Product Type Topload Washer
Purpose Service Procedure
Interchangeable Yes
Subject Balance Ring Contacting Tub Cover in Spin Cycle

Figure 3

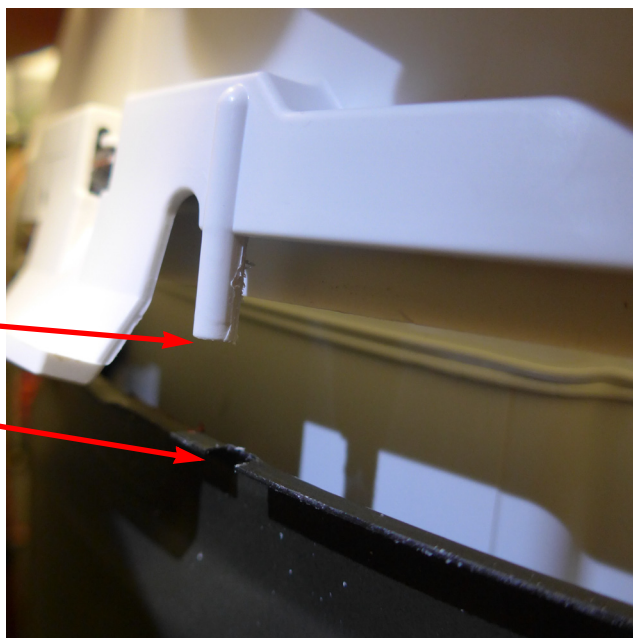
NOTE: When reinstalling the upper tub cover, the locator pin and notch in the outer tub must be properly aligned. Refer to *Figure 3*.

Properly align locator pin with notch.
